Item 8.**Section 4.55 Application: 93-97 Macquarie Street, Sydney - D/2017/1609/A****File Number:** D/2017/1609/A**Summary**

Date of Submission:	7 May 2024
Amended plans/Additional information	2 May 2025 and 2 June 2025
Applicant:	The Planning Studio
Architect/Designer:	BVN
Developer:	Census Advisory
Owner:	Macquarie Street Development Pty Ltd
Planning Consultant:	The Planning Studio
Heritage Consultant:	Weir Phillips
Cost of Works:	\$183,035,738.56
Zoning:	The site is zoned SP5 Metropolitan Centre under the Sydney Local Environmental Plan 2012. The indicative use is defined as a 'mixed use development', comprising 'residential accommodation', 'commercial premises' and 'food and drink premises', all of which are permissible with consent.
Proposal Summary:	This Section 4.55(2) modification application seeks to amend the concept consent for the redevelopment of the 'Stamford Hotel' building and adaptive reuse of the existing Heritage item known as the Health Building. Specifically, modifications are proposed to the concept envelope, including a minor reduction to the podium and tower setbacks on the north, east and southern boundaries, an increase in the overall height by 2.84 metre

Figure 10: Concept envelope comparison. Blue illustrates the approved Concept DA envelope, green illustrates proposed modifications to the envelope and pink illustrates a construction tolerance zone.

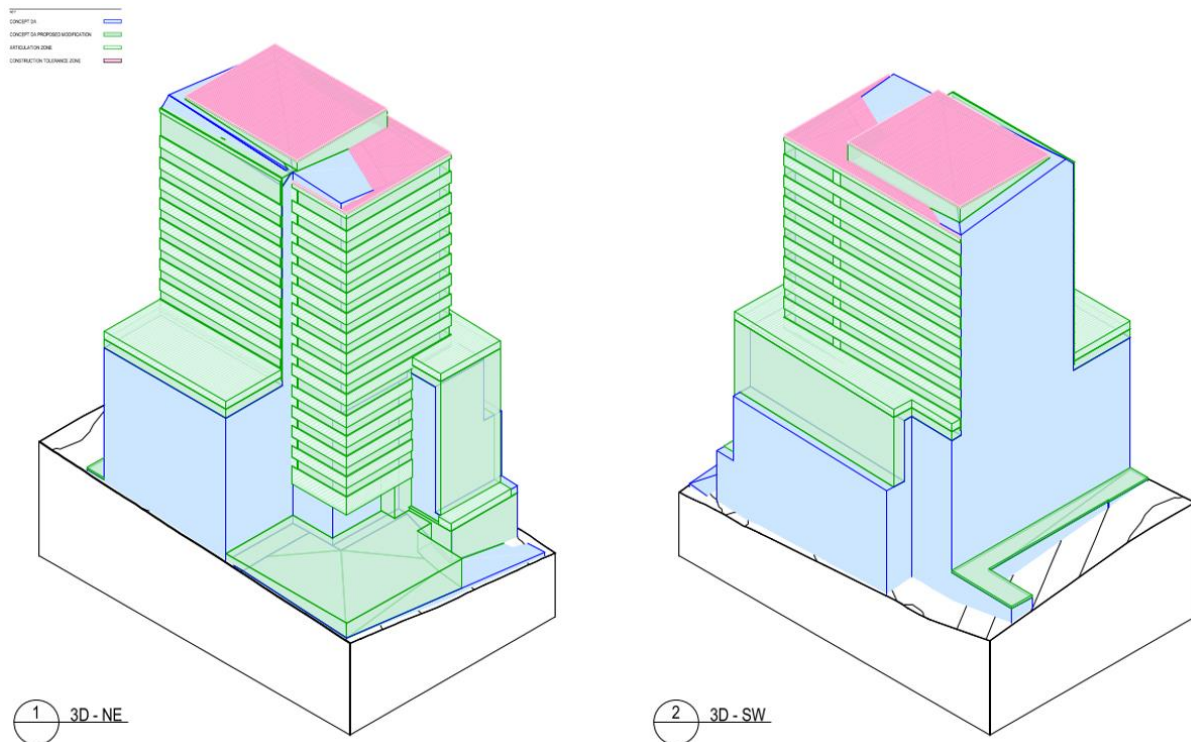
9. The subject modification application proposes to amend the concept consent to be consistent with the concurrent Detailed Design DA as outlined below:

Figure 11: Height plane showing extent of the proposed height of building breach

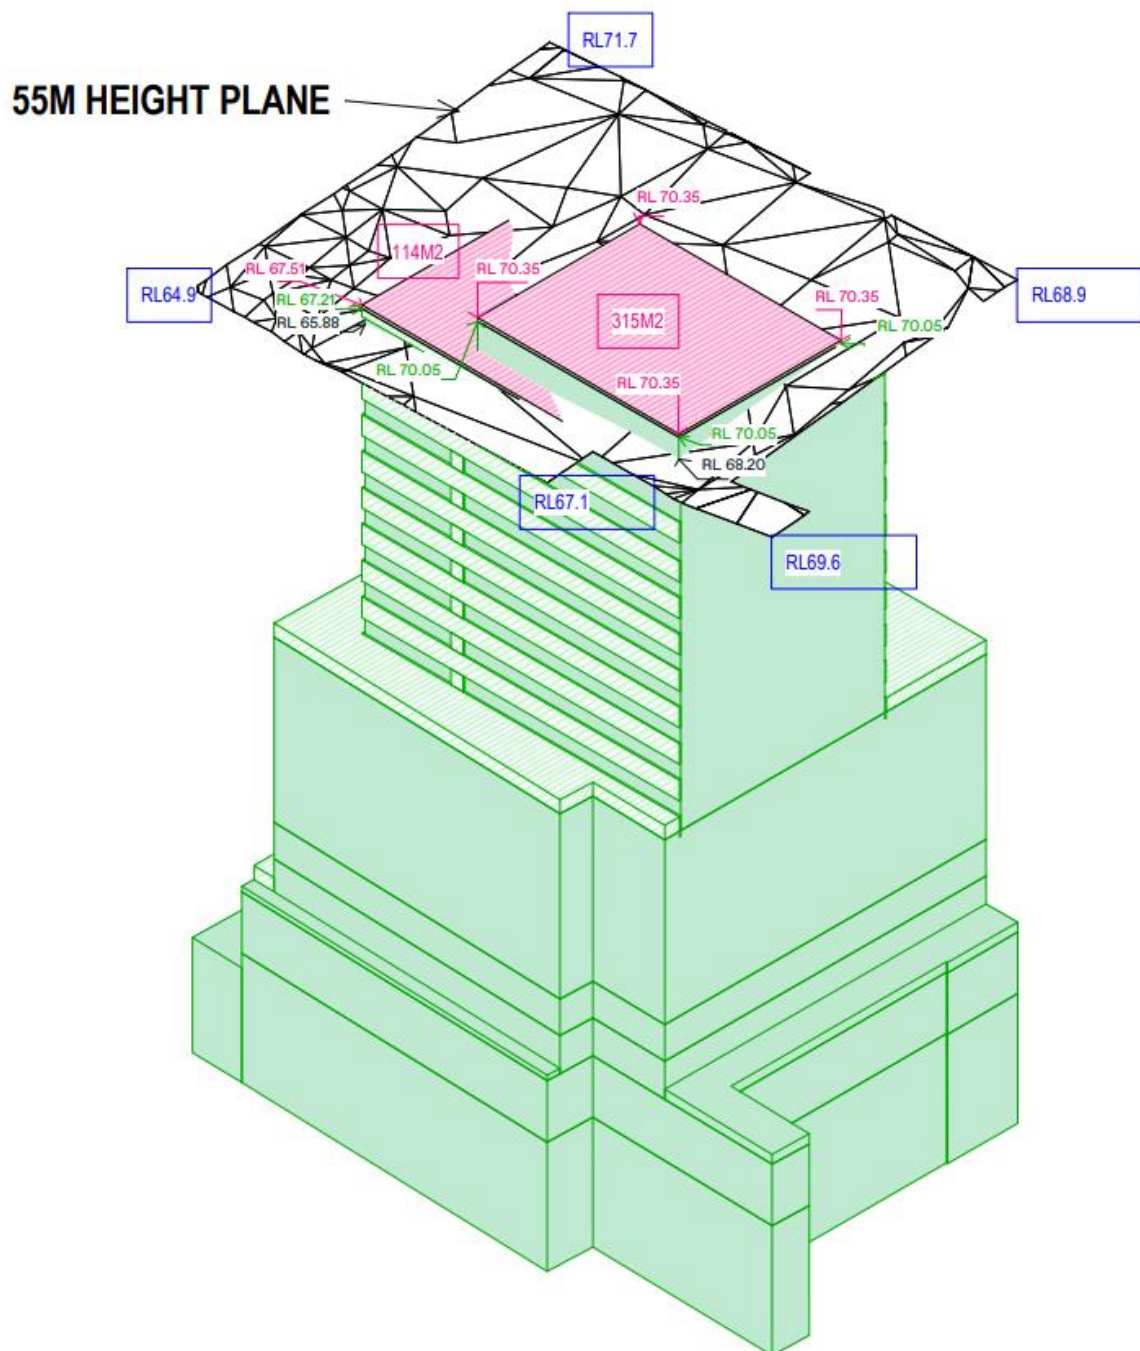
45. The site has a 55 metre building height development standard. The existing approved concept envelope is compliant with this 55 metre building height development standard, which is illustrated as a height plane across this sloping site.
46. The subject application seeks to modify the envelope as a result of the Detailed Design DA (and the winning design competition scheme of BVN) . The proposed modification seeks to increase the overall maximum height of building to 57.84 metres, representing a variation with the building height development standard of up to 5.1% or 2.84m. The extent of additional height above the 55 metre height plane is illustrated in Figure 11, below.

48. The proposed locations of the additional height on the building above the 55 metre height control is supported on the following basis:
- (a) A detailed view loss assessment has been carried out by the applicant as part of the original concept and has been supplemented by a further analysis as part of this modification application. The City's Planner has also undertaken independent view inspections from neighbouring properties as part of their assessment. Refer to view loss assessment below;

Figure 28: 13th Floor position D of the northern façade known as Viewpoints 16 and 17 in the supplementary report

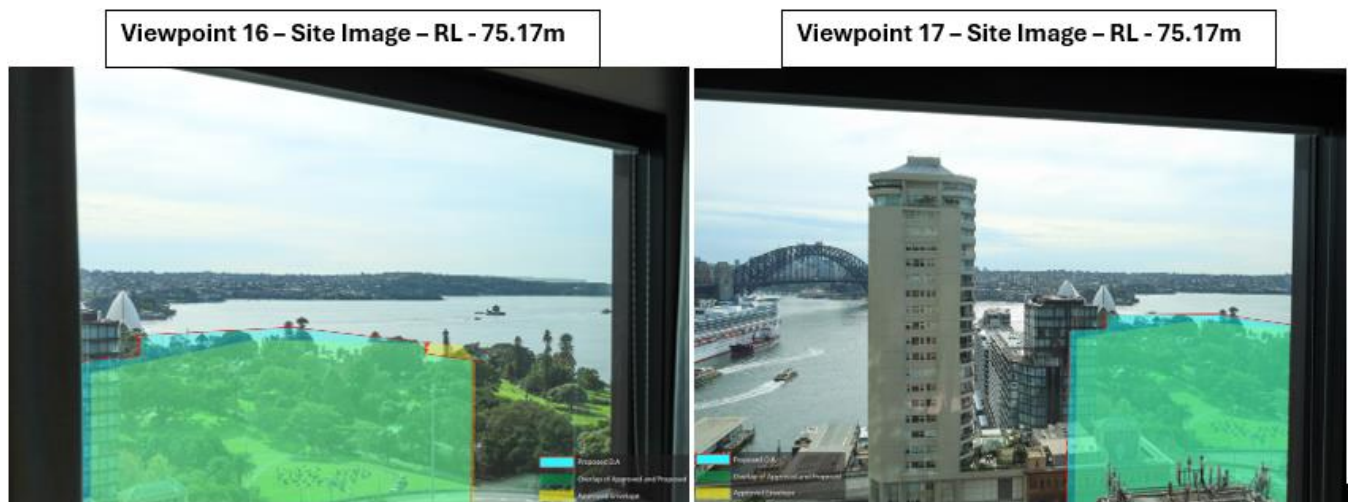
76. As part of the June 2025 VIA access to one room between levels 11 and 13 was provided by the InterContinental Hotel. Level 13 viewpoint D (known in this supplementary report as level 21 Room 2125) was physically inspected and is consistent with the view impacts analysis in the May 2025 VIA report. The view impacts are shown below.

80. Level 13 contains partial views of the Opera House from a standing position in the hotel rooms which are impacted. The proposed height and setback change would result in further restriction to the partial views to the Opera House at View Points A-C. The extent of impact when considering Tenacity Assessment is measured as Minor impact. View Points D-E contain a small impact to the partial view of the Opera House and include minor loss of general harbour views. The extent of this impact is measured as Negligible.

Figure 30: Height plane showing extent of the proposed height of building breach

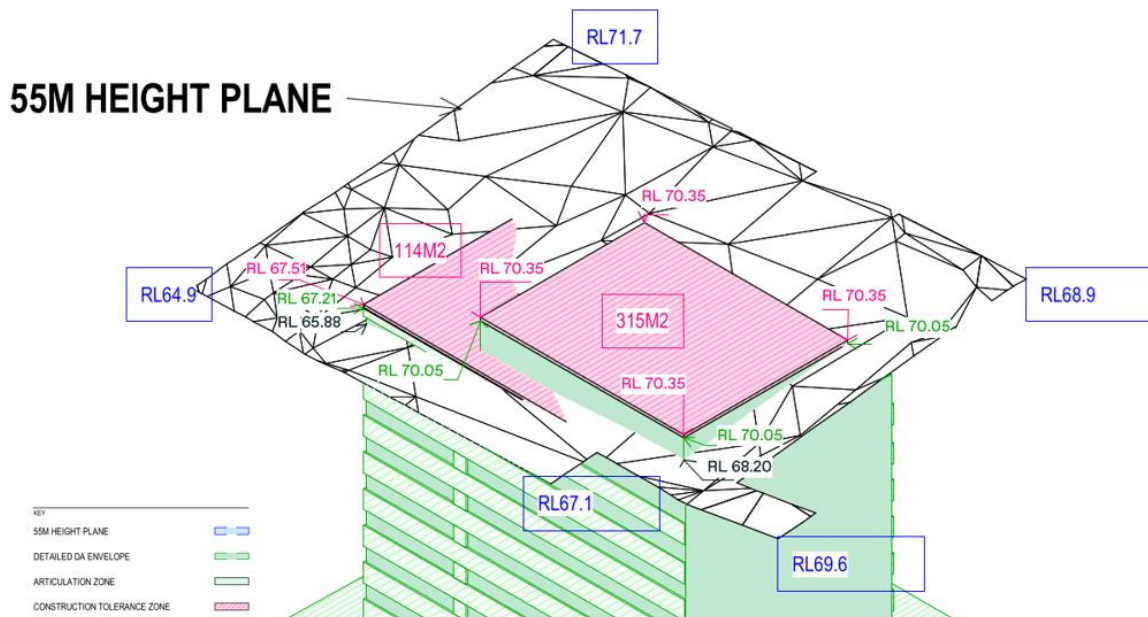
84. Before the reasonableness of the proposal is concluded, the Tenacity Assessment process also prompts the question to whether a more skilful design would result in a lesser view impact and achieve the same development potential and amenity.
85. The modification and concurrent detailed DA lodged contain a proposal that has been subject to a comprehensive, detailed and extensive design process which has included a successful Architectural Design Competition. The design does include a proposed variation to the Building Height development standard of up to 5.1% or 2.84m. As shown below, the extent of additional height above the 55 metre height plane is illustrated in Figure 30, below.

86. As shown, the breach is largely because of the sloping nature of the site and is centralised mostly to the rooftop plant room. To ensure a high-quality architectural outcome, the plant room had been designed to accommodate all required infrastructure whilst housing the plant in the rooftop so it is not visible from the public domain and neighbouring buildings. The height variation and its planning justification is discussed further in this report and the concurrent detailed design DA.

Figure 31: Extract from the architectural design report showing rationale for podium heights

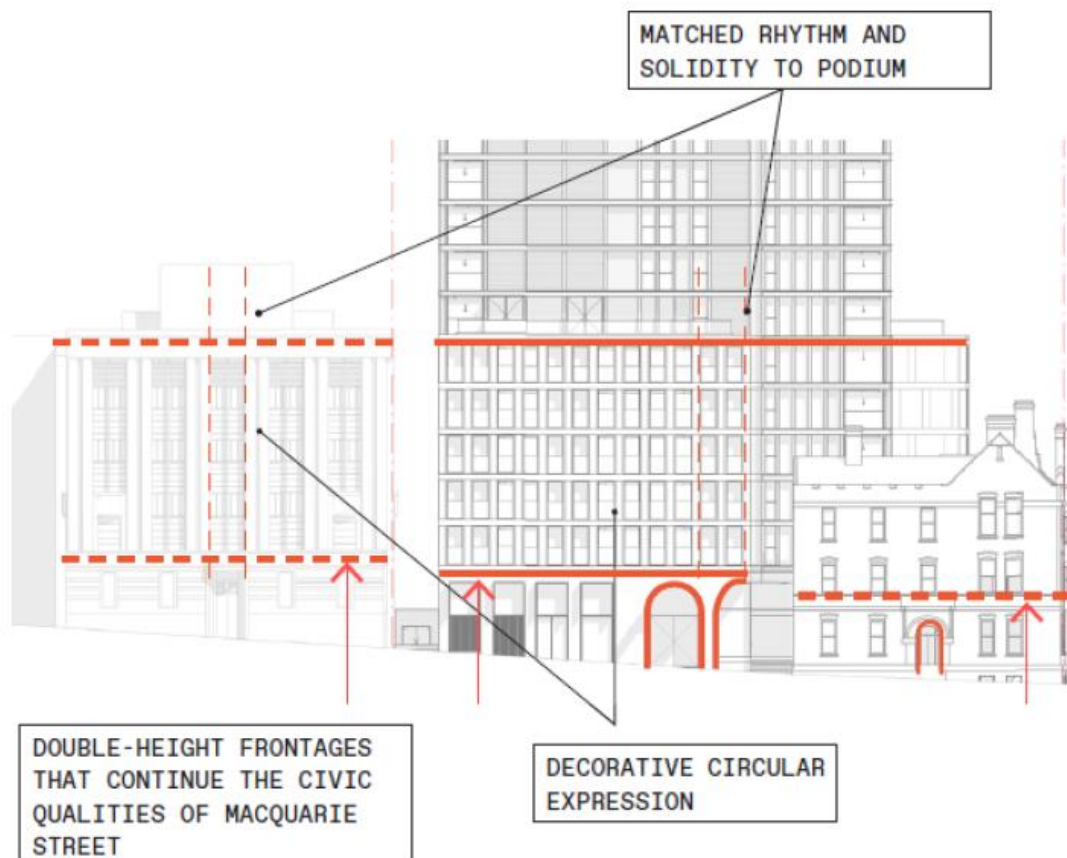
- 99. The approved concept envelope provided a podium height of RL 36.00 along Macquarie Street and RL 36.00 along Albert Street. The modified envelope proposes an increase to RL38.35 along both Streets.
- 100. The modified upper datum of the podium is informed by the height of Transport House, while the geometry of the arched building separation is informed by the ornate entry to the former Health Department Building as shown below:

101. The proposed modification to increase the height of the podium was part of BVN's winning design competition scheme and commended by the Jury.
102. Although the proposal exceeds the maximum street wall height along Albert Street, this is considered acceptable as the height responds to the podium set by Macquarie Street. The increase is acceptable and is consistent with the objectives of Section 5.1.1.2 of Sydney DCP 2012, considering:
 - (a) The proposal ensures an appropriate height transition from the neighbouring Transport House; and
 - (b) The distinctive qualities of the Macquarie Street special character area are maintained and the development respects the scale form and proportions of area.

Figure 33: Level 1 concept envelope plan (with the blue line and text being the approved concept DA and green line and text being the proposed modifications)

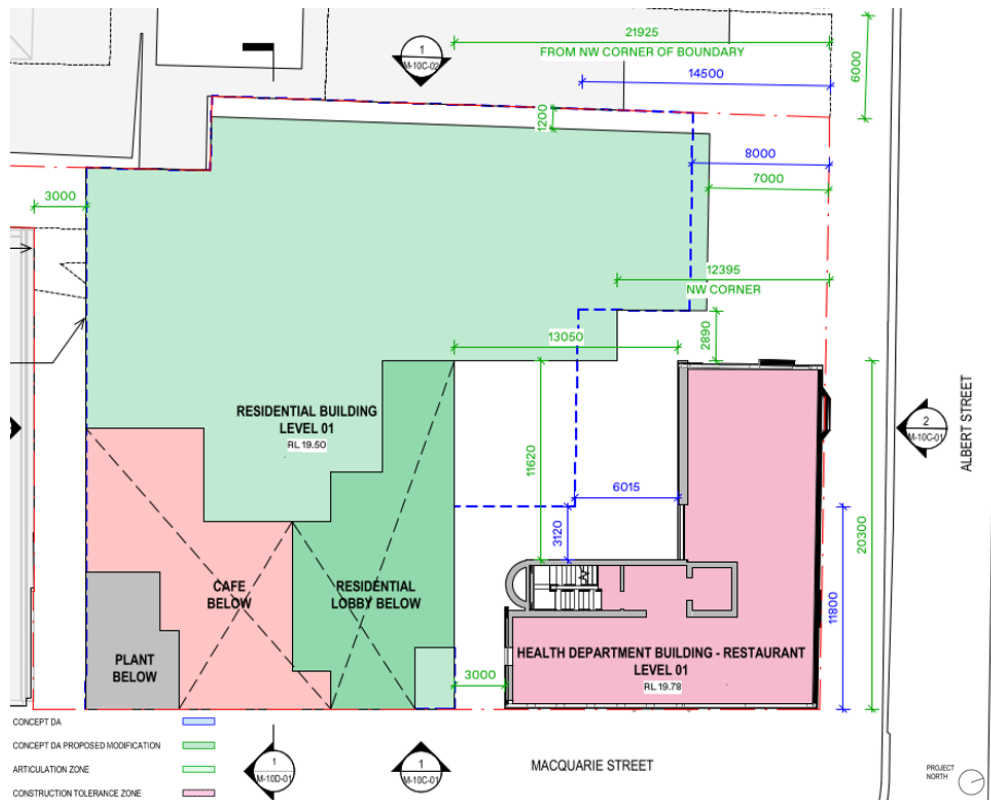
103. The existing concept consent approved an 8m podium setback and 13m tower setback from its Albert Street (northern boundary) frontage, consistent with the DCP provisions.
104. The proposed modification and detailed design seek a minor variation and propose a setback of 7m for Levels 2-6 and 12.245m for levels 7-15 from this northern boundary, as shown in Figures 33 and 34, below:

105. The proposed 0.755m-1m reduction from the existing approved envelope does not impact the amenity of former Health Building or neighbouring properties. The variation in setback would not be perceptible beyond that already approved and would not result in varied amenity or environmental impacts. The proposed variation in the setback still allow the Former Health Building to remain prominent, forward of the new development and able to be read from Phillip Street.

Figure 35: Concept envelope section showing the averaging change to the podium on the right side (and approved concept DA shown in blue outline)

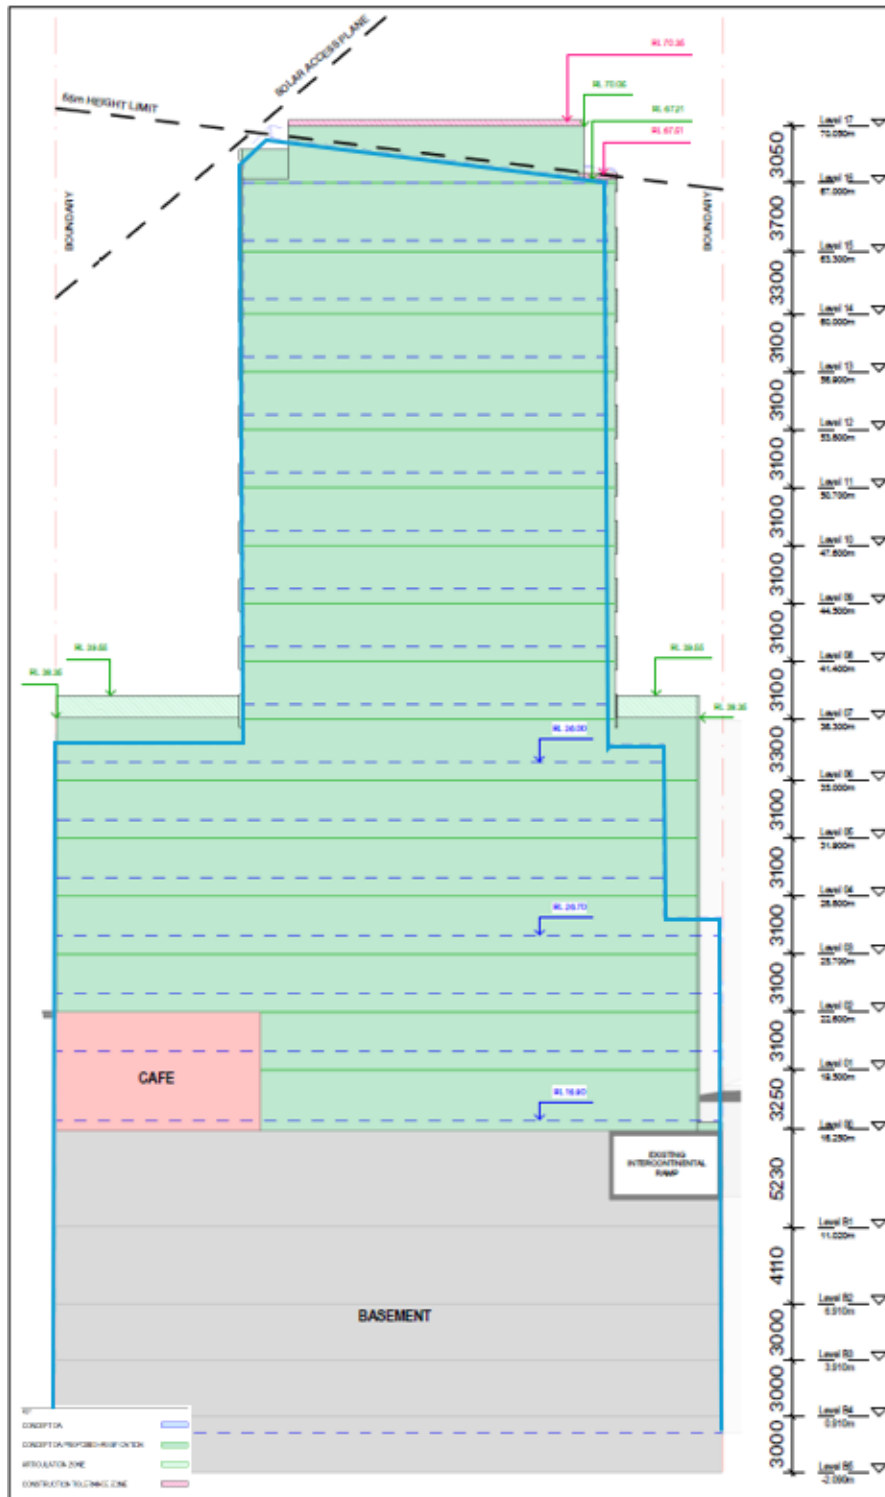
109. The concept consent approved a nil setback from the western boundary (where the Police and Justice Museum is located) for Levels Basement to 2 of the envelope, 3 metres for Levels 3 to 5 and then a 6 metre setback for Level 6 and above of the tower. Figure 35 illustrates the approve envelope and proposed modifications to the setbacks.

110. A key component of the winning scheme from the design competition was the averaging of the western podium. The winning scheme sought to vary the stepping setback design approved in the concept DA and instead sought to create a simplified straight wall to be sympathetic and non-obtrusive backdrop to the Police and Justice Museum. The subject modification seeks to adopt revised western boundary setbacks for the podium and lower levels of a nil setback for levels B5 to level B1 and a 1.2 metre setback from Level 00 to Level 6.
111. The western setback for the tower seeks to amend the approved concept envelope that was parallel to the western boundary. The revised envelope and concurrent detailed design seeks to adjust the alignment of the western facade to square off the envelope and to be instead parallel with the eastern facade. This would allow for a more simplified construction.

Figure 36: Level 8-15 envelope illustrating the realignment of the envelope to the western facade

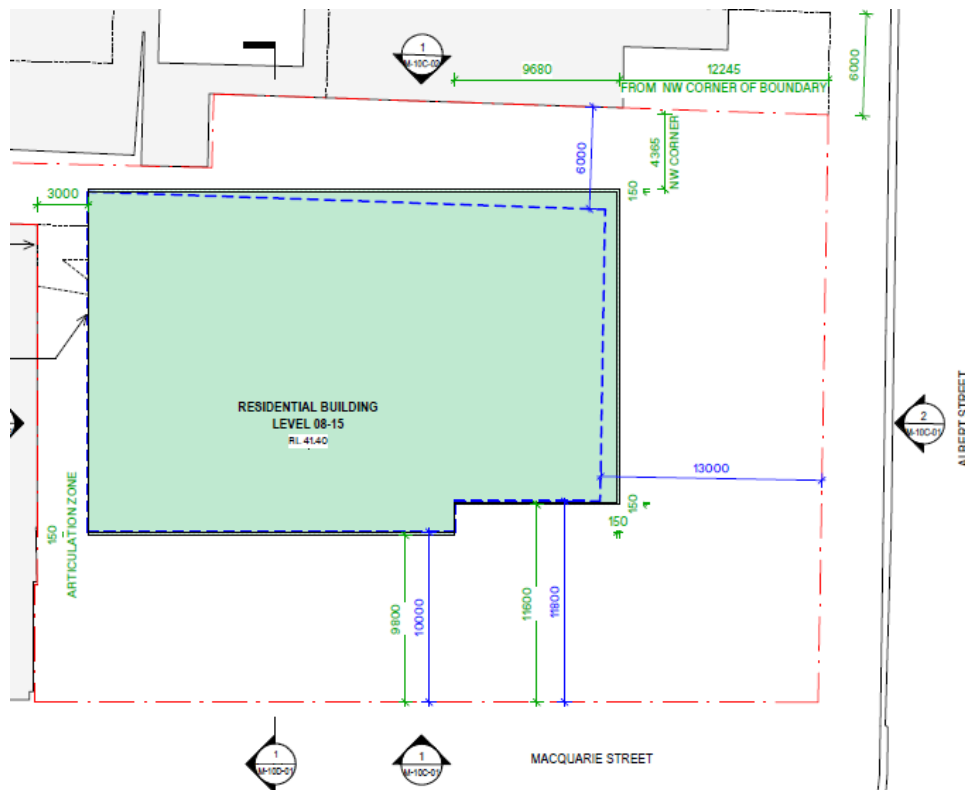
112. The realignment of this facade would result in a variable reduction in setback from the this western boundary for the tower of between 5.7m and 4.3m. The proposed straightening of the tower's western facade has no effect on views to the tower from Phillip and Albert Street. The massing retains the simplicity and street character noted in the design competition jury report.
113. As is addressed in this report, the variation proposed in the setback do not unreasonably impact on views from neighbouring properties. The minor proposed variations in setbacks do not cause additional adverse overshadowing to neighbouring properties or public domain. The proposed variation to the western setbacks are acceptable in the above context and is consistent with the objectives of Section 5.1.1.1 of Sydney DCP 2012.

Figure 37: Extract from the architectural design report showing the rational of the courtyard space and development volume

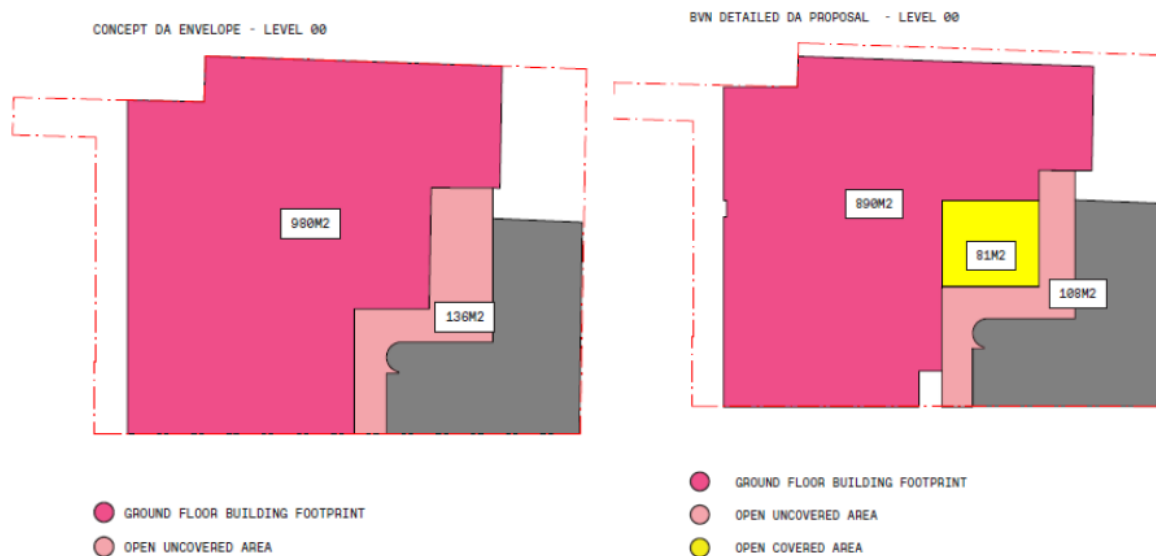
114. When compared to the existing approved Concept DA envelope, the proposed modified scheme accommodates a design that contains a double height open space at ground level and Level 1. The proposed modification seeks to increase the setbacks of the envelope from the former Health Department building on these levels to 11.62 metres to west of the heritage building and 13.05 metres from the south of the heritage building.
115. The modified proposal does propose a reduced setback on Level 2 upwards from the approved 6m setback from the southern wall of the heritage item to approximately 3.3m. There is a minor variation in the approved envelope setback from the heritage item from the western wall of the heritage building from 3.12 metres to 2.92 metres.

116. This change was supported by the design competition jury, as this design positively redistributed bulk in its averaging strategy. To compensate for the reduced setback on the upper levels, the additional open space courtyard area has been provided at the ground floor.
